Technical Solutions

Upgrade of Neo to Release 3 – Change in AOI Functionality from Release 2

Products Affected – Neo

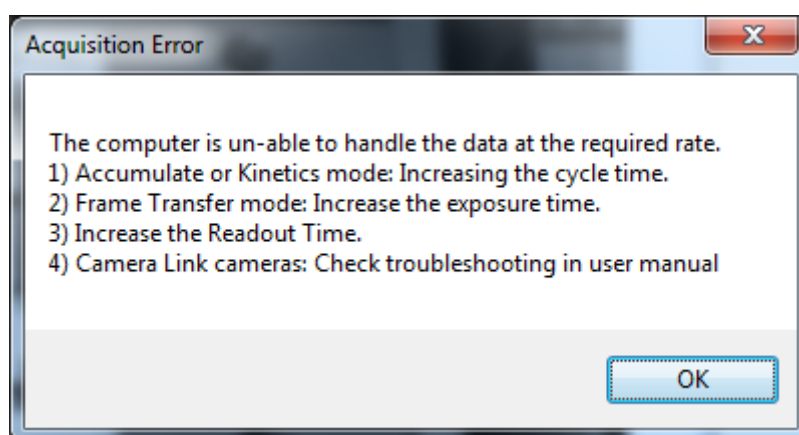
Description of Error: After the firmware upgrade of the Neo camera to Release 3, the camera is no longer able to acquire area of interests (AOIs) that it was previously capable of acquiring. Please see the error message below.

Note: This is assuming that the frame grabber card has not been moved to a different PCIe slot (the Neo frame grabber requires a minimum x8 slot). If the PCIe slot has not changed and if a full resolution image is not able to be acquired, check that your PC meets the required specification for operating the Neo. Please refer to the Andor Neo Specification Sheet for the recommended PC specification.

As such, the software will generate an error message to indicate this. The upgrade of the Neo therefore increases the efficiency at which the data is transferred by the camera firmware and as such, if the control PC does not meet the recommended specification, a higher specification control PC will be required.
